Presenter: Jared Ecklund-Senior Planner

Sue Warfield

CEDAR LAKE

St. Louis County October BOA Meeting

Applicant sketch

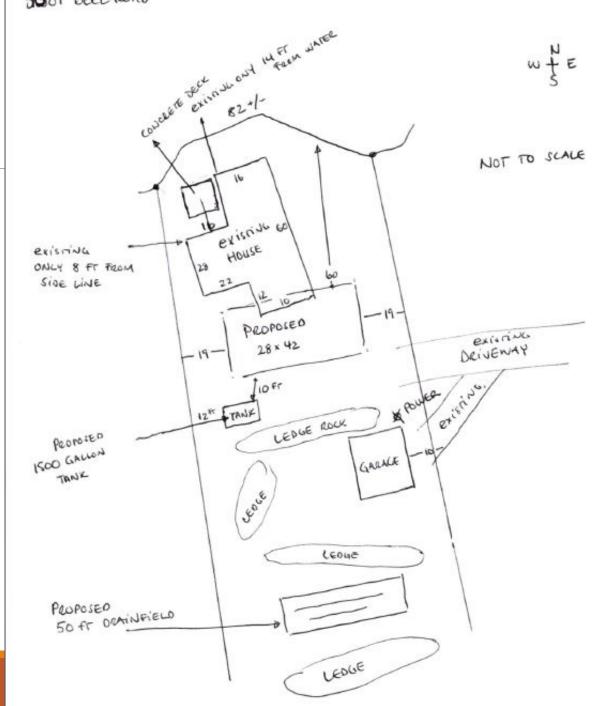
The applicant is also requesting approval for the structure to be located at a reduced property line setback.

The proposed structure is locate 19 feet from both property lines where 20 feet is required.

The last part of the request is for approval for the structure width to exceed 40 percent of the lot width.

- The lot width at the building site is approximately 65 feet. 40 percent in this location is 34 feet.
 - The applicant is proposing a structure width of 42 feet where 34 feet is allowed.

Survey and potential buildable area

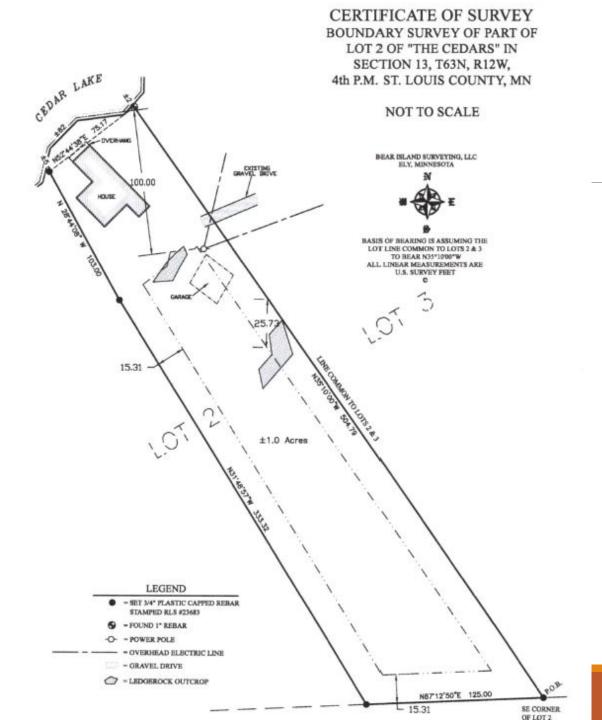
There is approximately 12-15 feet between the proposed dwelling and the first piece of ledge rock on the property.

The setback of the structure could be increased slightly before the ledge rock starts.

It appears there may be enough width on the property at the proposed building site for the structure to meet the property line setbacks.

- The width of the property at the proposed building site is approximately 84 feet.
- The proposed structure of 42 feet in width should be able to meet the property line setbacks, if centered on the property.

- The structure shall be unobtrusive (earth-tone) colors, including siding, trim and roof.
- 2. The shoreline setback for the proposed structure shall be maximized to the greatest extent possible, and shall be no closer than 60 feet from the shore.
- 3. The stormwater runoff from the proposed structure shall not discharge directly into the lake or on adjacent lots.
